# UNITED STATES PATENT AND TRADEMARK OFFICE

10/807,592

**Office Action Summary**

## **DETAILED ACTION**

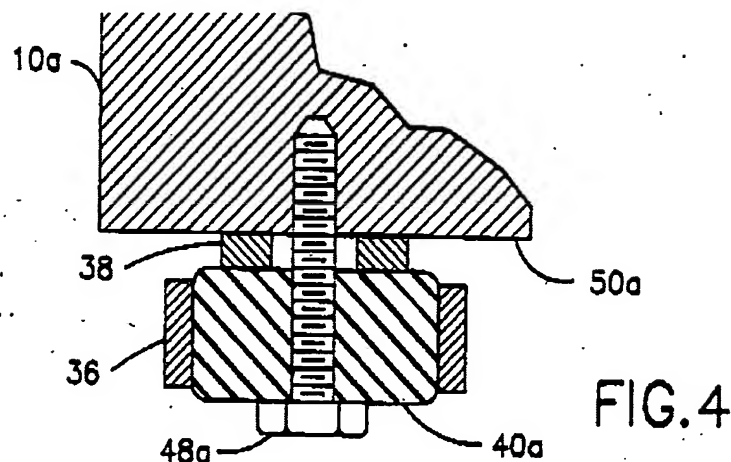
Lin teaches a fastener comprising an integrated isolation member (Fig 1) composed of a resilient material (body 34 described as compressed in abstract, and since it is described as for absorbing shock, it is inherently resilient). It is capable of fitting within a drive cage slot (Fig 3 - unit 1/10/20/30 could clearly fit in a slot) and it would abut a cage surface when so engaged. It has an outer wall and axial portion (Fig 1) and threaded stud (16), head (10's surface 1--see Fig 3) and shaft (15)-mounted washer (20) between head and stud. Lin does not teach a sleeve as required.

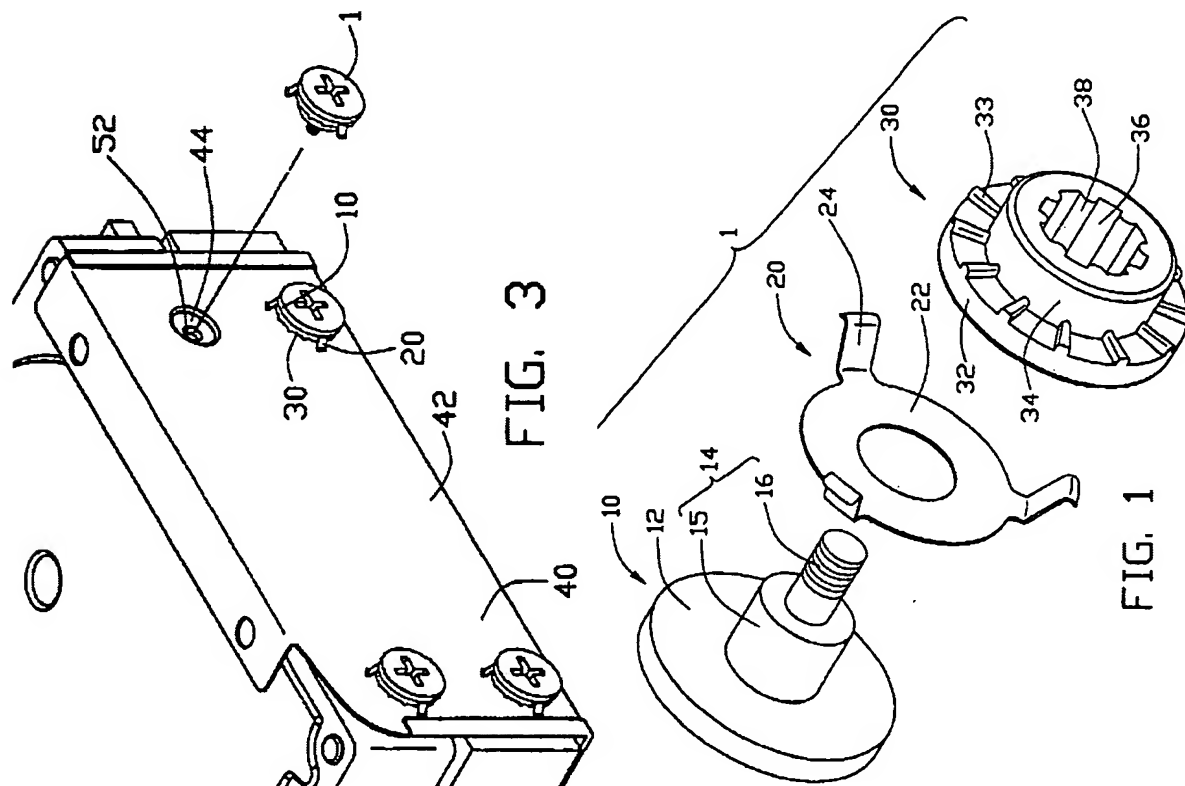
However, the fasteners are not taught as having a resilient or elastomeric isolation member or having a washer mounted on the shaft between the head and stud. Grassens teaches fasteners with resilient isolation members in Figs 1 and 2, and col 2 lines 30-41 teach that resilient isolation members are well known to be used to absorb shock and vibrations for mounting electrical apparatus to a chassis, and col 2 lines 30-41 are specific that a washer can be used such that a resilient isolation member is provided on the washer between the washer and the head when the mounting surface is irregular or resilient. Note that "36" is NOT considered part of the Grassens fastener or the modified Felcman/Grassens fastener. The isolation member includes an outer wall and an axial portion. Were the fastener 50 of Felcman modified per Fig 4 of Grassens, (excluding "36" which would not be part of the modified fastener), the outer wall would be capable of abutting the drive cage surface and the axial portion would fit within the drive cage slot. The metal head, shaft, and threaded stud are a single unit (screw), and the threaded stud is considered the part as labeled below:

Washer 38 is in contact with the shaft via its contact with intermediate member 40a. Absent any further limitation, the washer axial portion is approximately the same diameter as the outer head diameter. Examiner takes Official Notice that it is old and well known in the art to have resilient isolation members made of thermoplastic elastomers to dampen vibrations, and to have a fastener head selected from commonly used fastener heads to coordinate with existing drivers.
